Technical Service Bulletin (TSB)

Flash: Powertrain Control Module (PCM) Updates

REFERENCE:	TSB: 18-066-23 GROUP 18 - Vehicle Performance	Date:	May 24, 2023	REVISION:	18-101-22 REV. A
VEHICLES AFFECTED:	2019 (DJ) RAM 2500 Pickup 2019 (D2) RAM 3500 Pickup This bulletin applies to vehicles equipped with a 6.7L I6 Cummins Turbo Diesel Engine (Sales Code ETL) or a 6.7L I6 Cummins HO Turbo Diesel Engine (Sales Code ETM).			MARKET APPLICABILITY: ☒ NA ☐ SA ☐ EE ☐ MEA ☐ IAP ☐ CH	
CUSTOMER SYMPTOM:	Customers may experience a Malfunction Indicator Lamp (MIL) illumination. Upon further investigation the technician may find that one or more of the following Diagnostic Trouble Codes (DTC)s have been set: • **P061B-00 - Internal Control Module Torque Calculation Performance. • P0299-00 - Turbocharger Underboost.** • P0461-00 - Fuel Level Sensor 1 Performance. • P0506 - Idle Control System RPM - Lower Than Expected. • P20EE - NOx Catalyst Efficiency Below Threshold. • P1451-00 - Diesel Particulate Filter System Performance. • P242F-00 - Diesel Particulate Filter Restriction - Ash Accumulation. • P2463-00 - Diesel Particulate Filter Restriction - Soot Accumulation Bank 1. • P026B - Injection Timi

Fig. 1
CP3.3 Design Pump

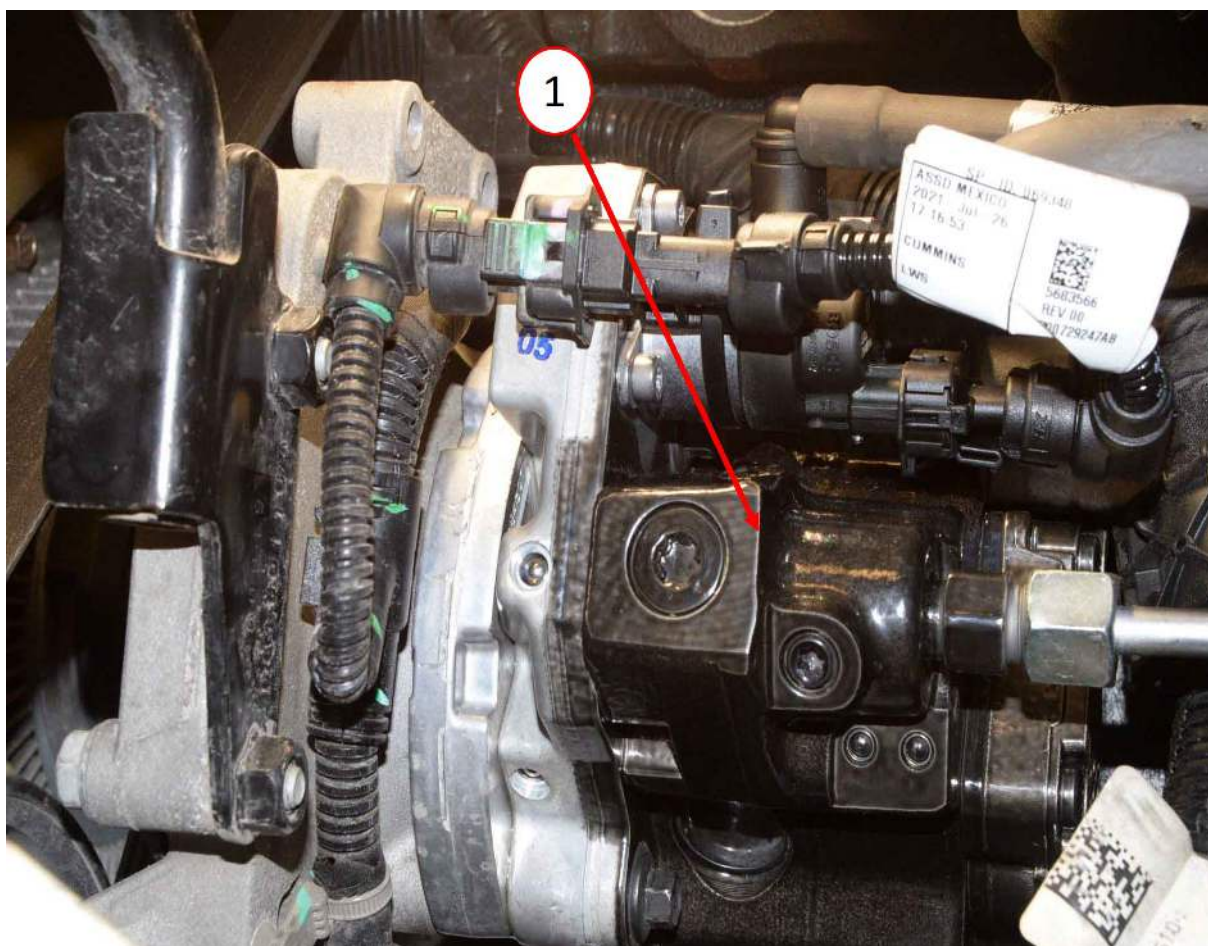
NOTE: The only calibration available will be for the updated CP3.3 design High-Pressure Fuel Injection Pump (Fig. 1) . Please ensure that recall Y78 has been completed first before proceeding with this update.

1. Inspect the High-Pressure Fuel Injection Pump to see which pump is currently installed on the vehicle (Fig. 1) . Also review the vehicle VIP report to see if campaign Y78 has been performed.

2. Does the VIP report indicate that Y78 has been performed, and is the vehicle equipped with the new design fuel injection pump released under the campaign?
 - YES>>> Proceed to [Step 1](#).
 - NO>>> Perform the Y78 campaign first. Once the campaign is performed, new pump installed and PCM updated, the PCM will have all of the updates listed in this document. This Bulletin does not apply.
